Approved Section 75W Modification Application

in respect to MP 09_0153

UTS
DR CHAU CHAK WING BUILDING

MP_09_0153-01-75w submission
Floor plan mark-ups

Level 9 - changes to fly-bys

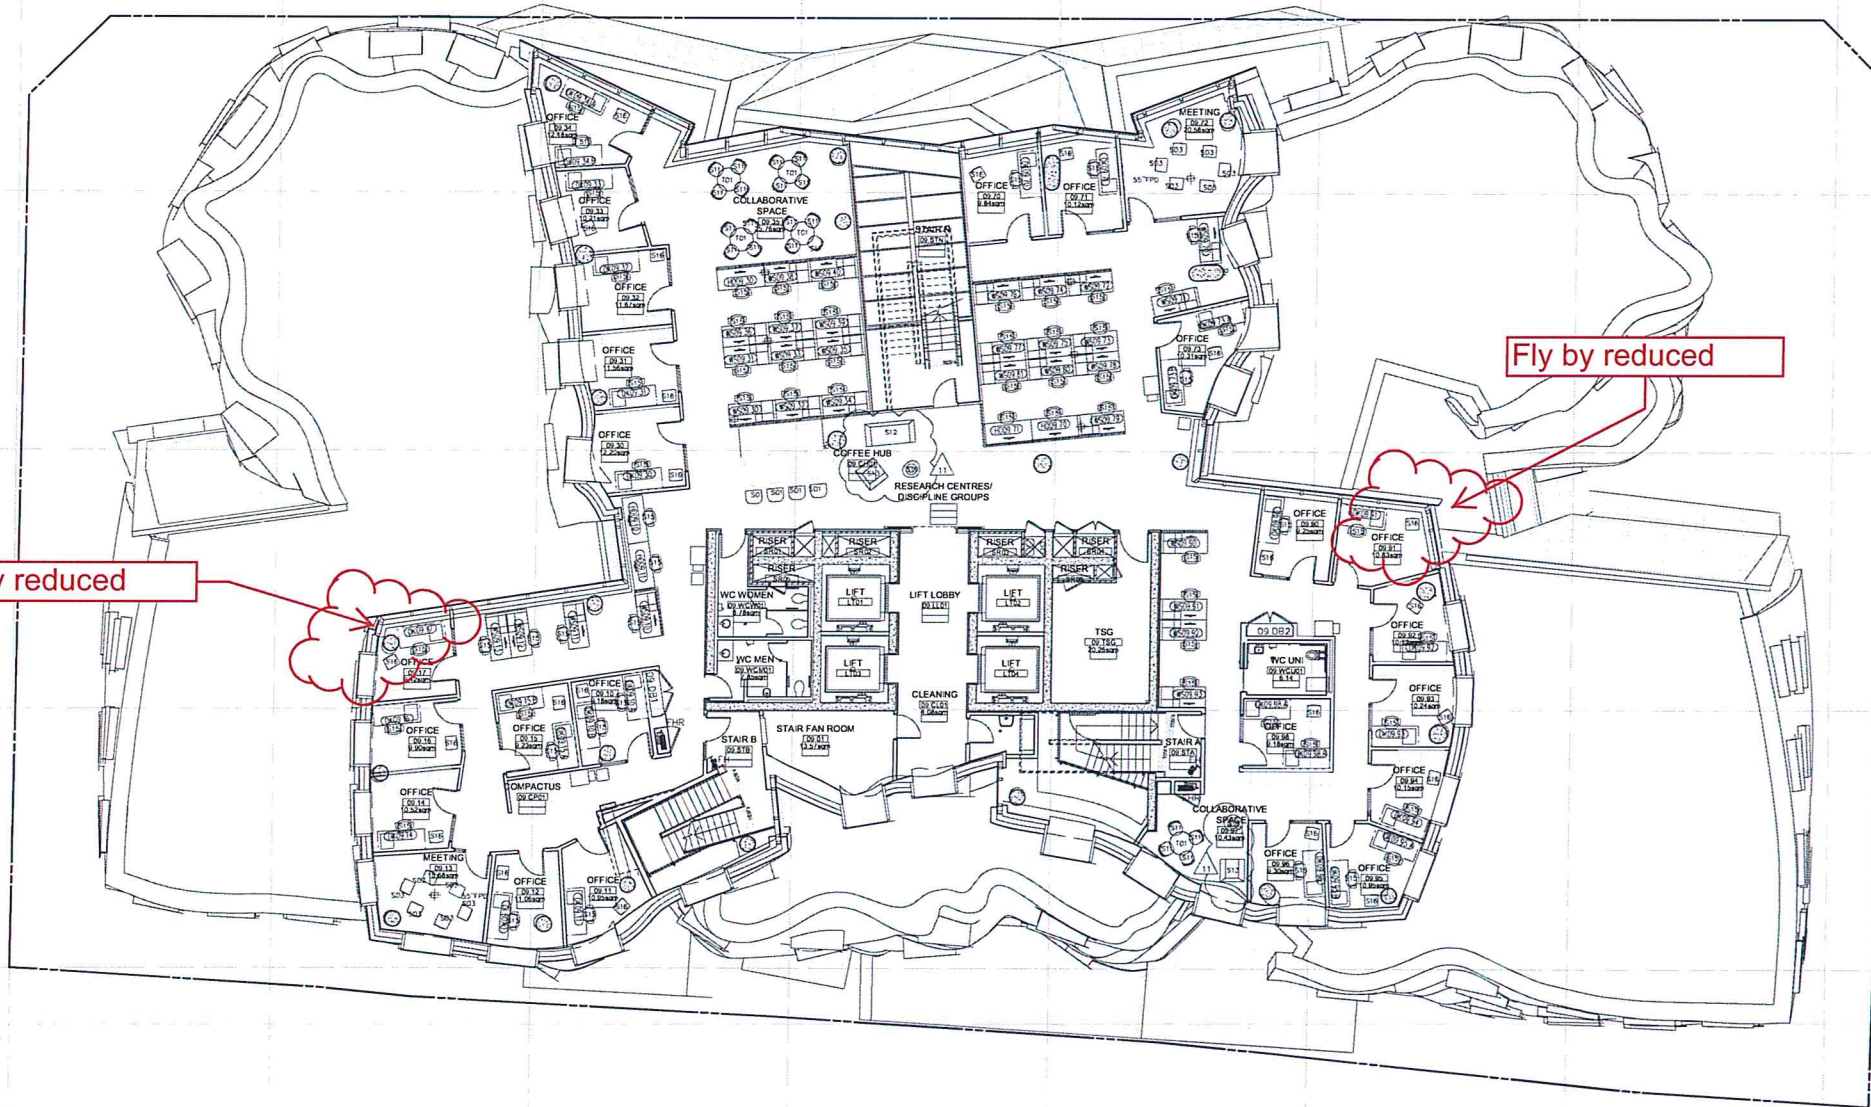
Fly by reduced

Fly by reduced

THIRTEENTH FLOOR
PLAN

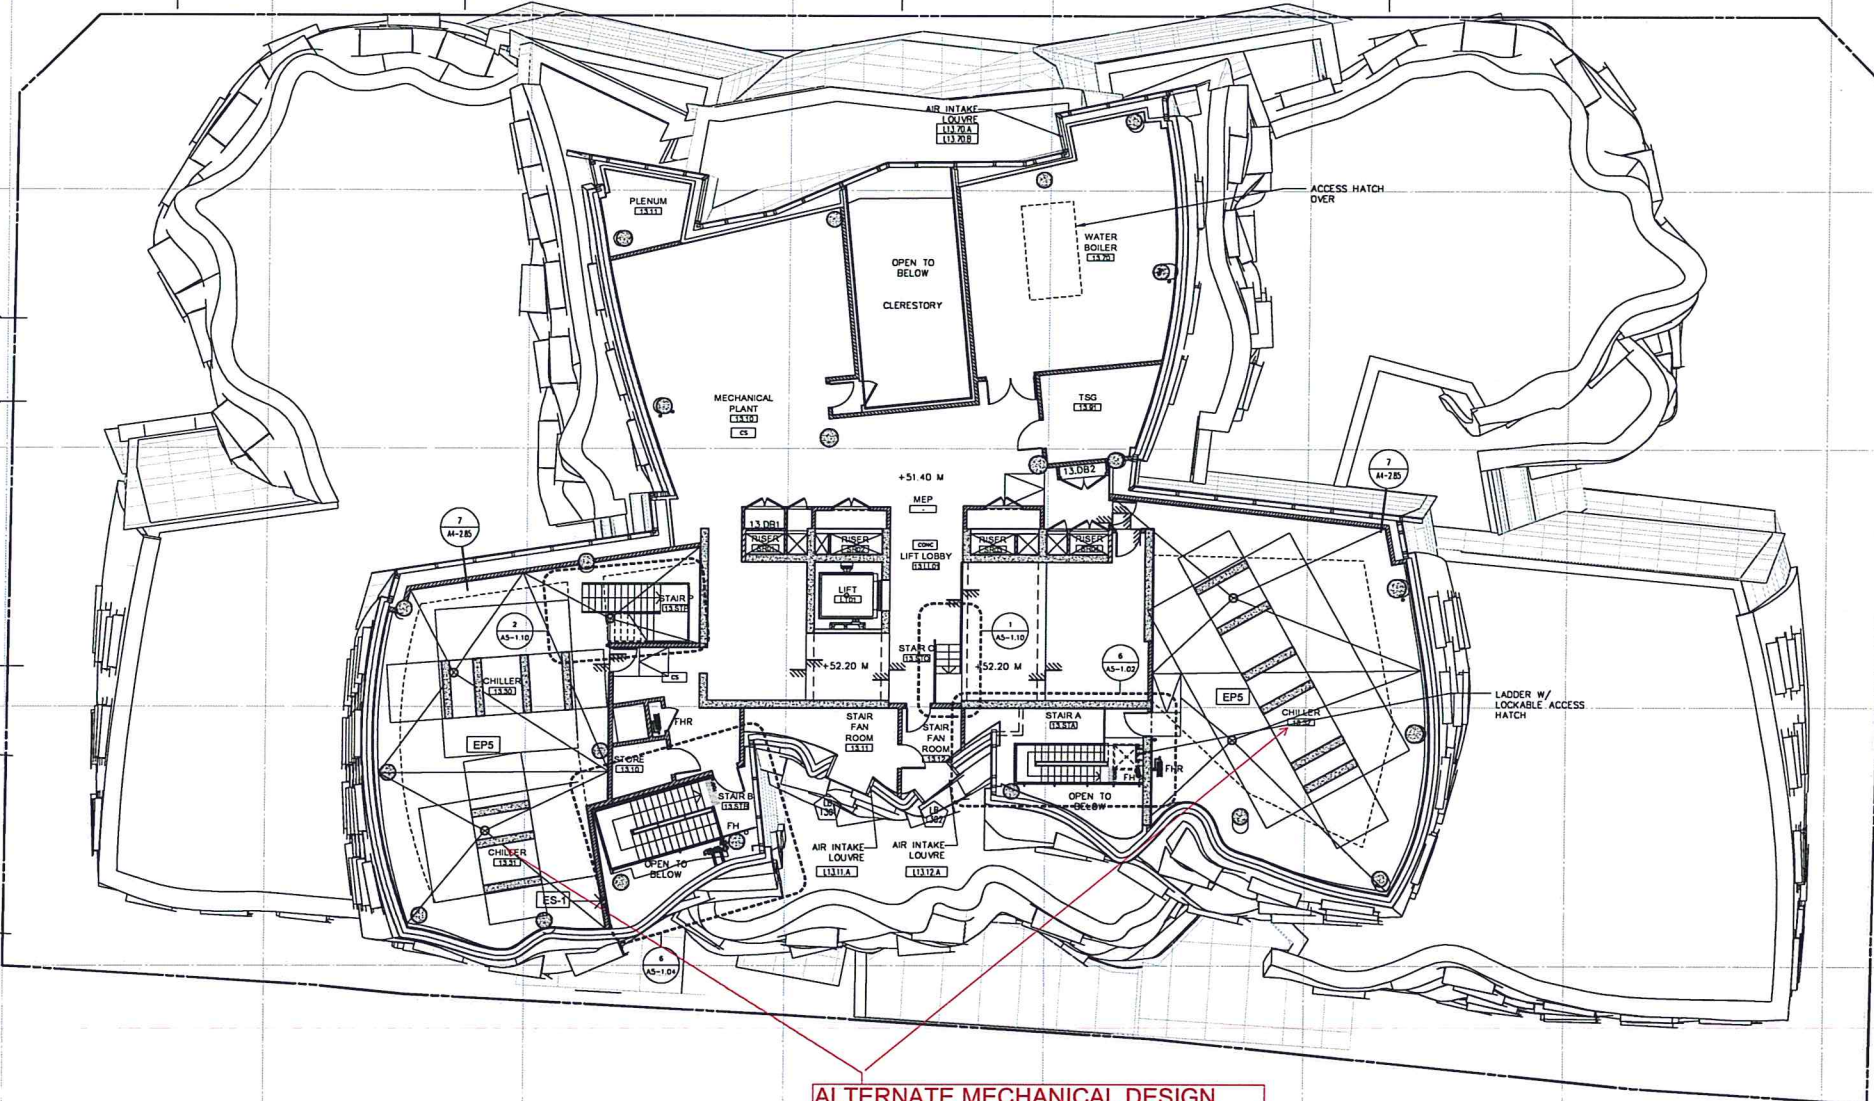
ALTERNATE MECHANICAL DESIGN
SOLUTION REPLACEMENT OF
COOLING TOWER AND TRIGEN PLANT
WITH AIR COOLED CHILLERS

CONSULTANTS DRAWING NUMBER
FULL BUILDING WEST ELEVATION

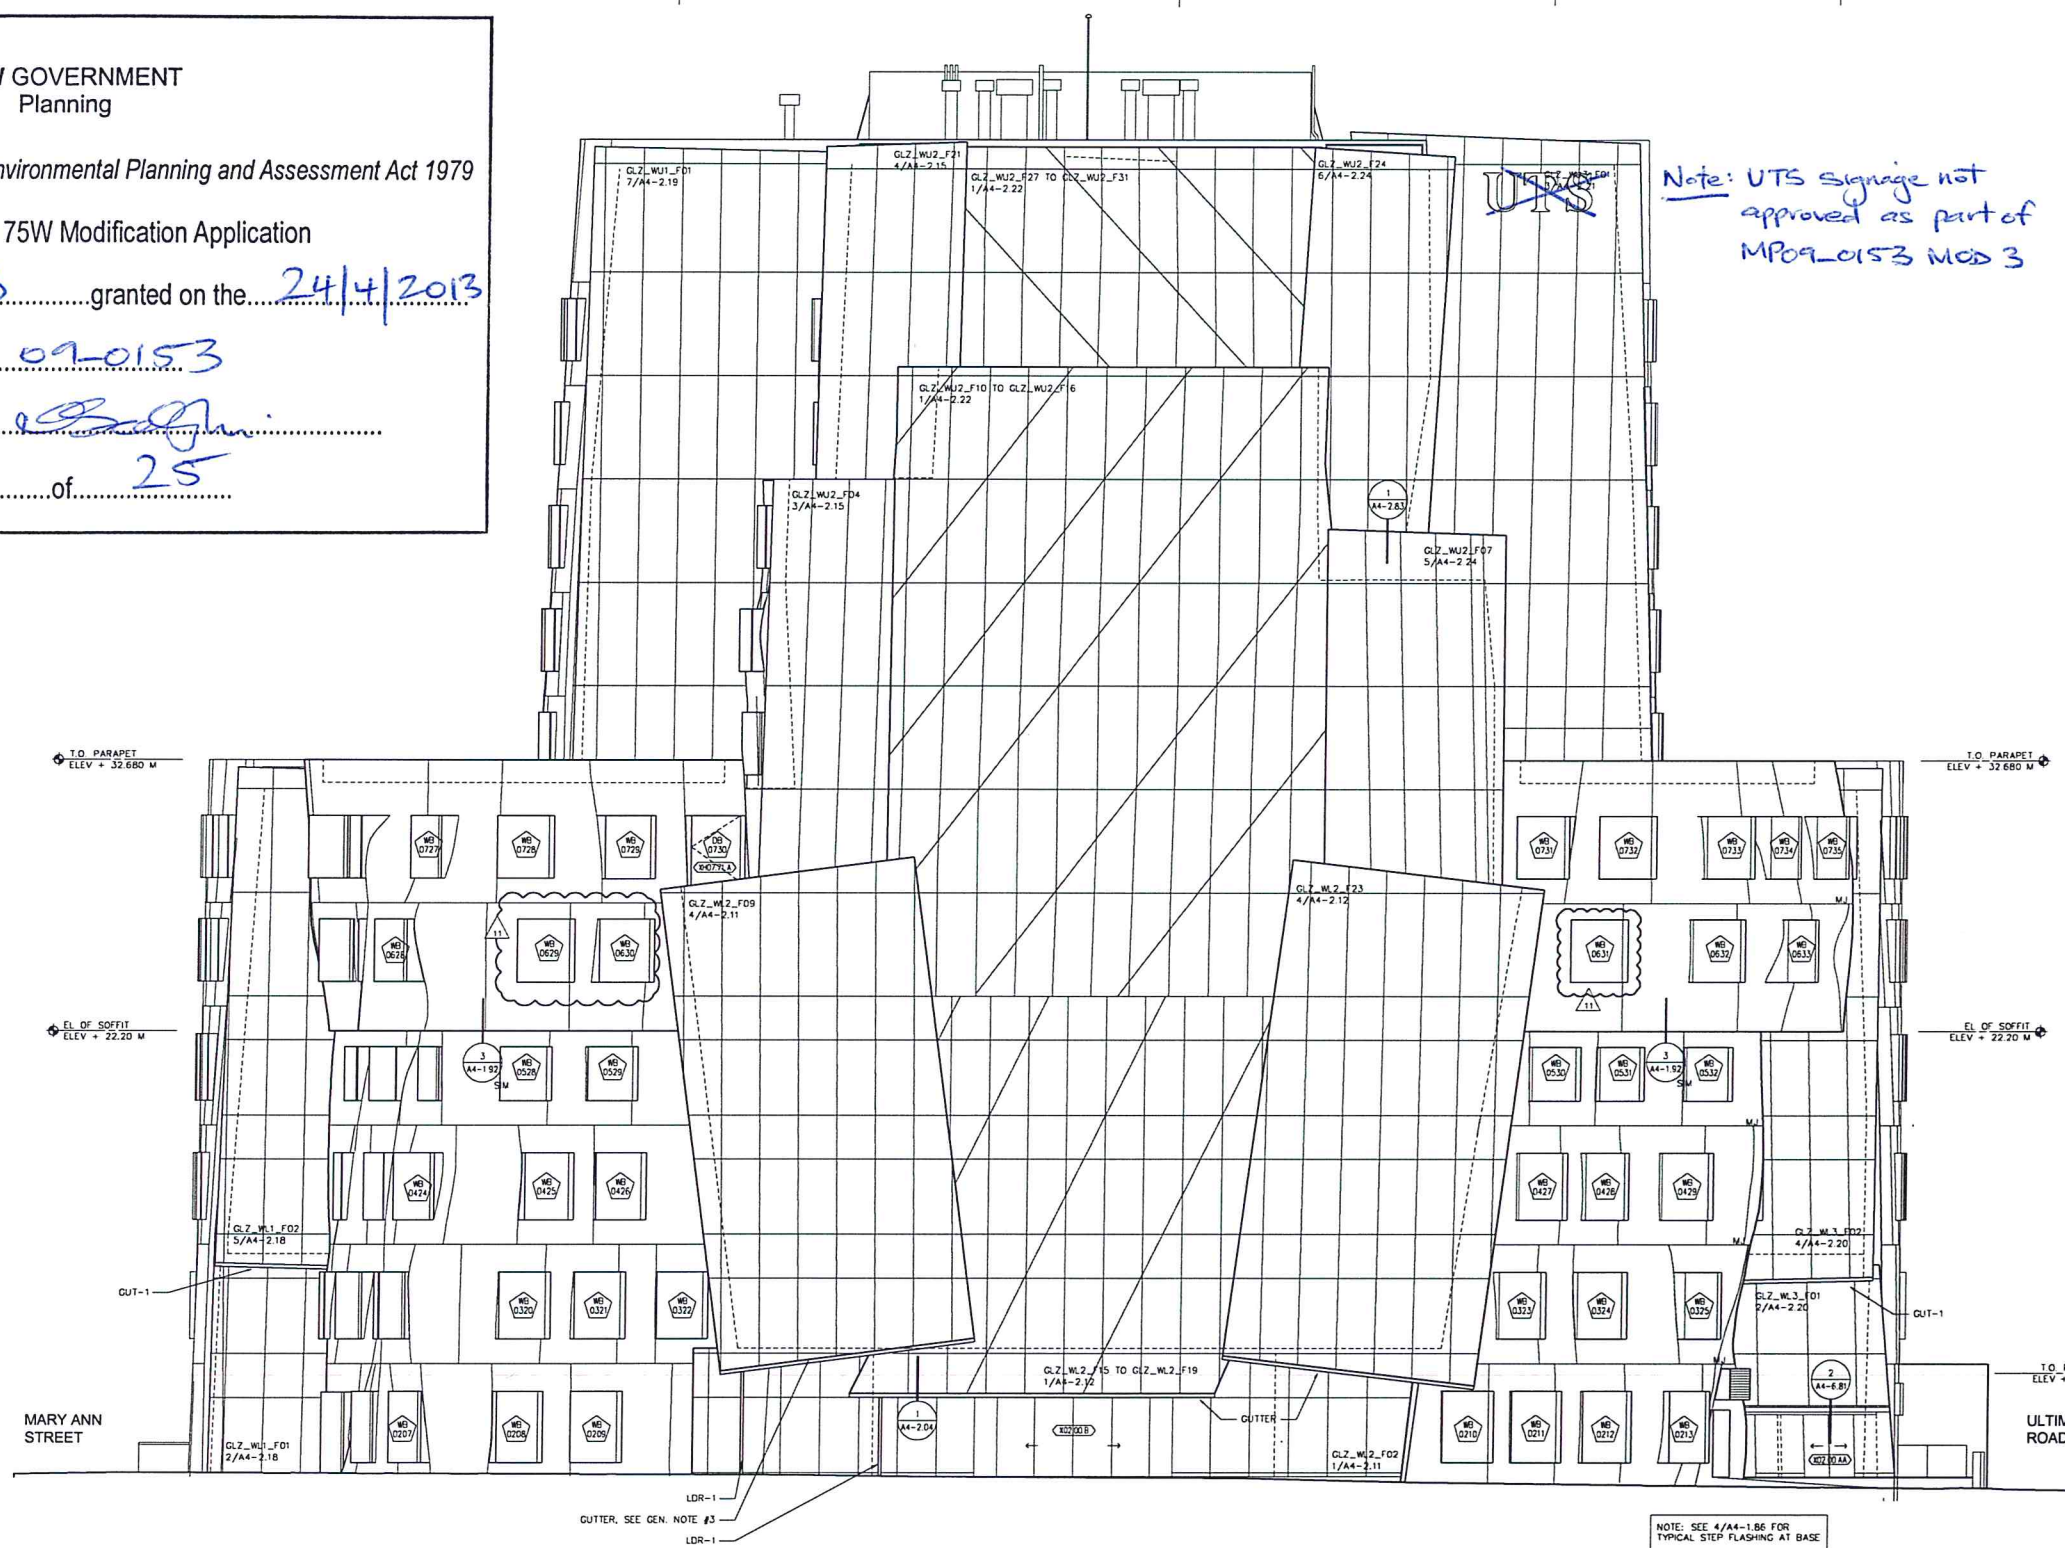
SPRINKLER TANK
RL REVISED FOR
CONSISTENCY

1 FULL BUILDING SECTION
SCALE 1:100

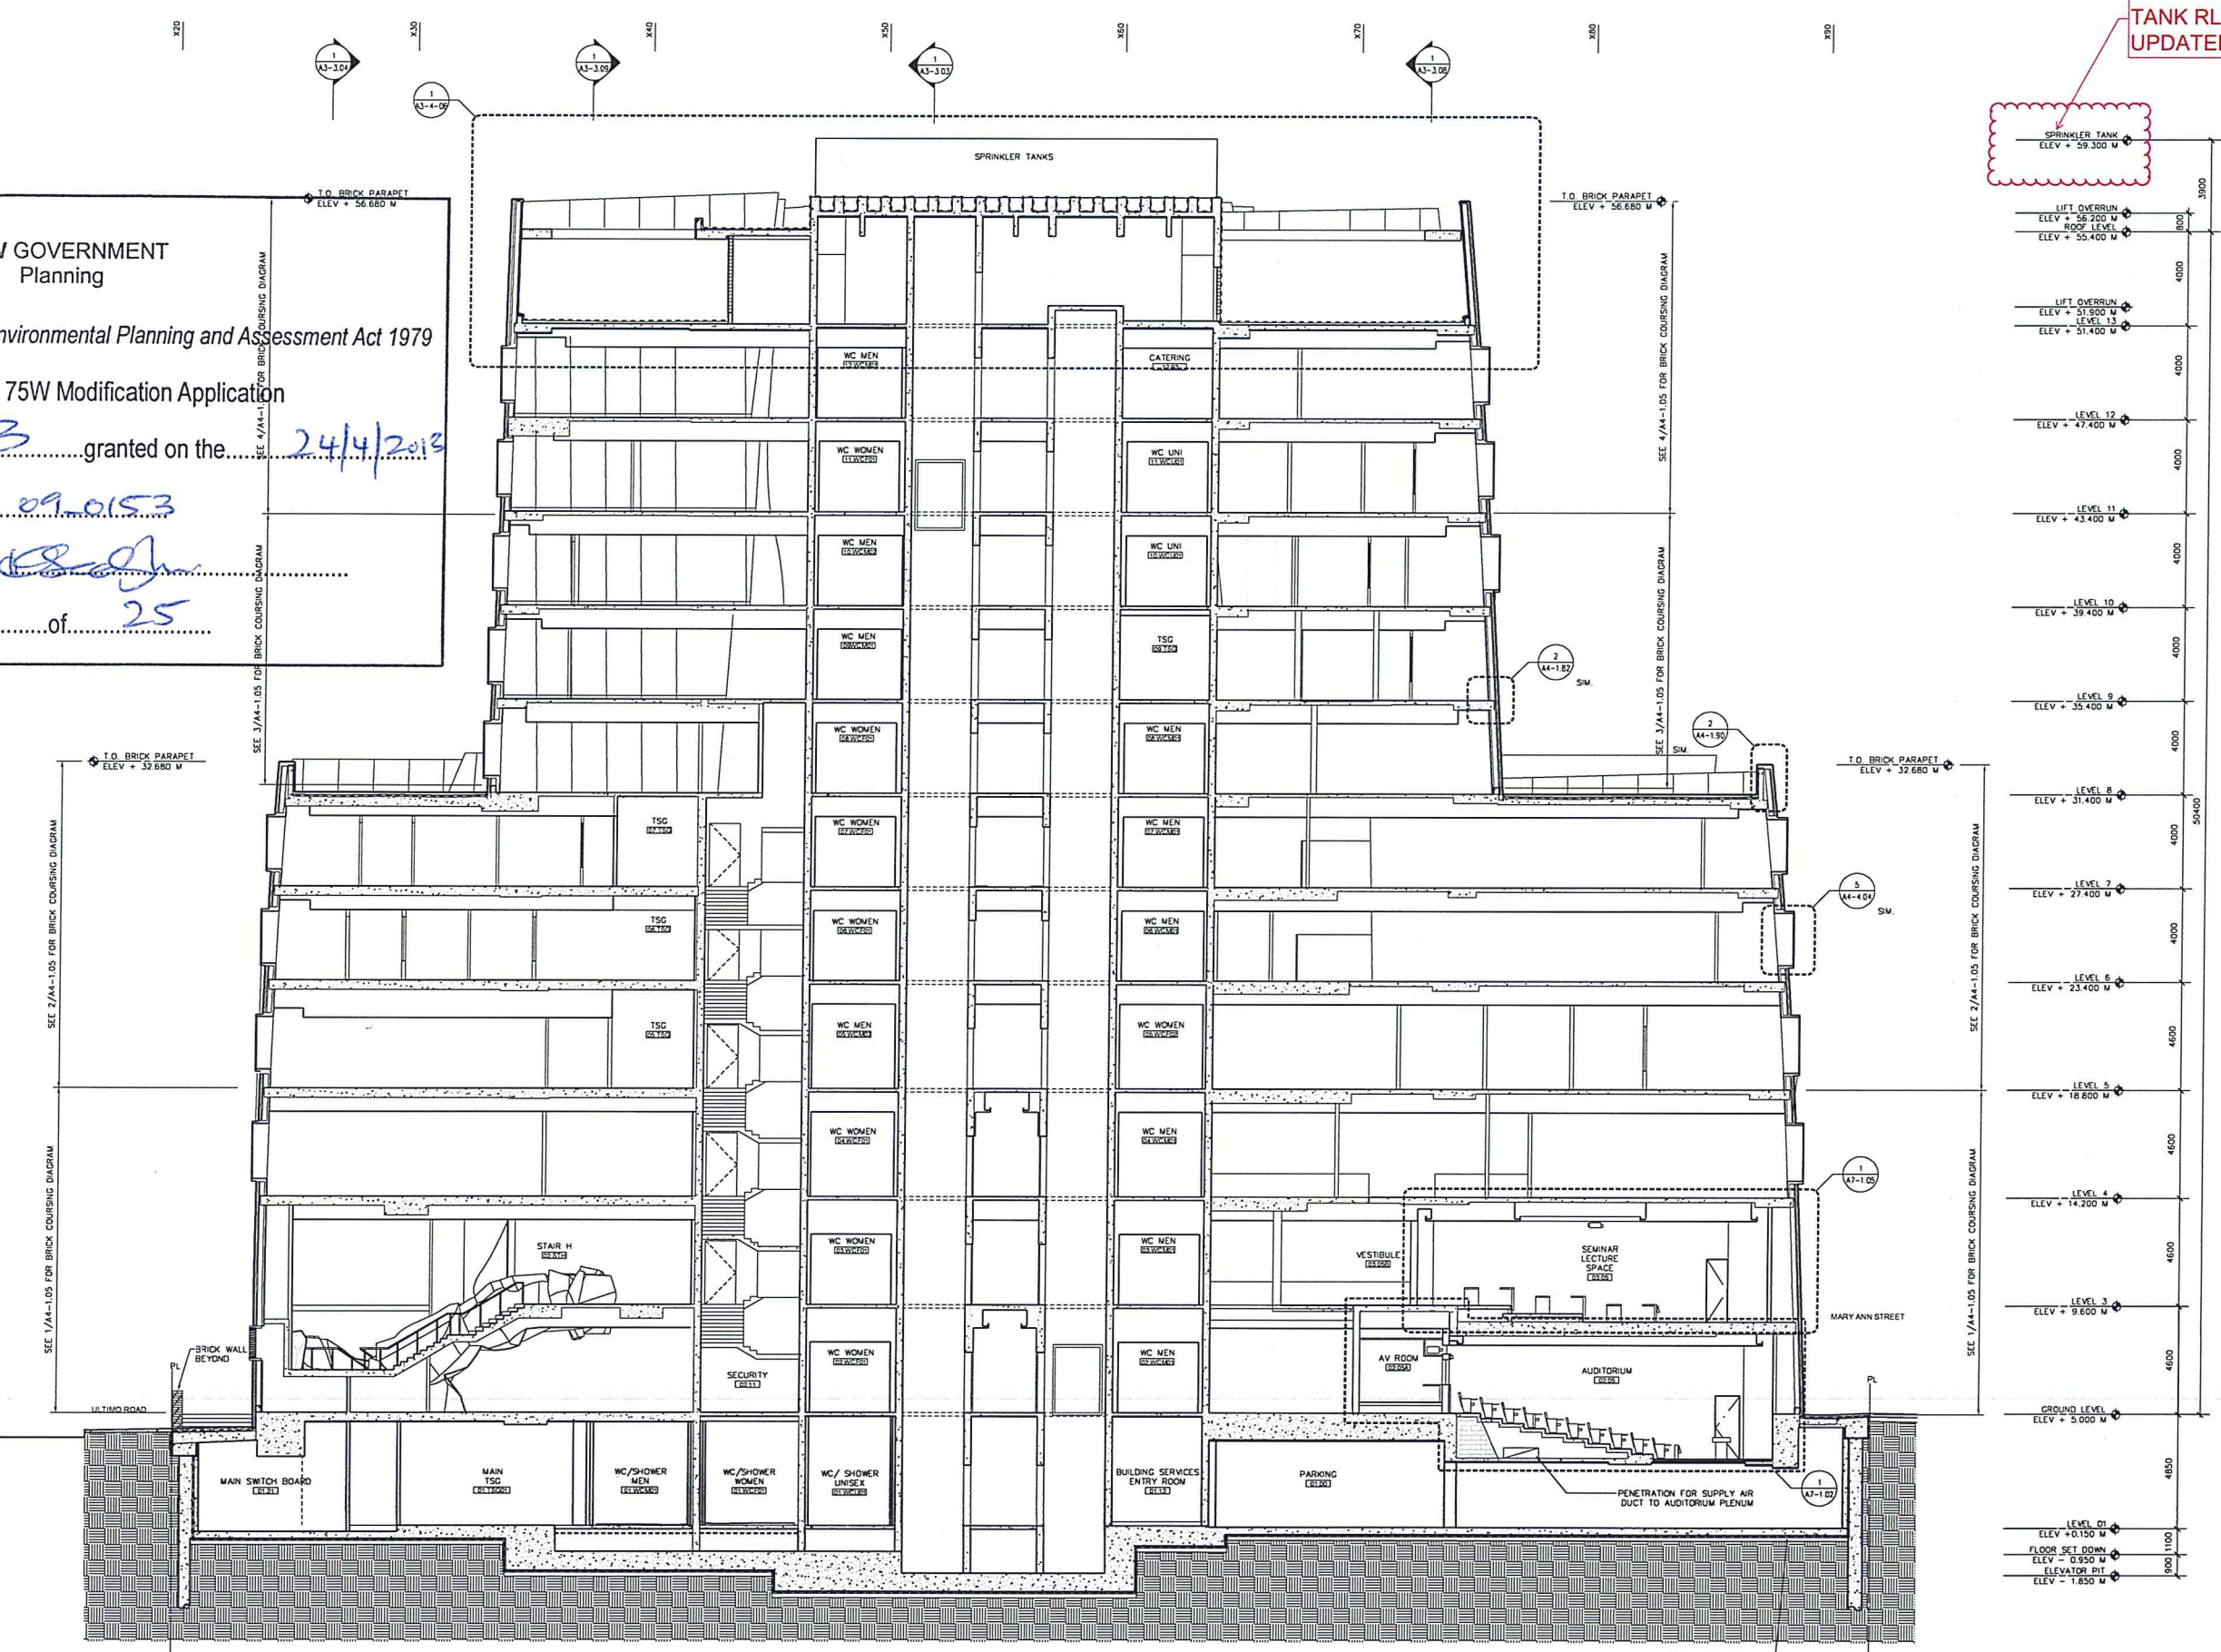
SPRINKLER
TANK RL
UPDATED
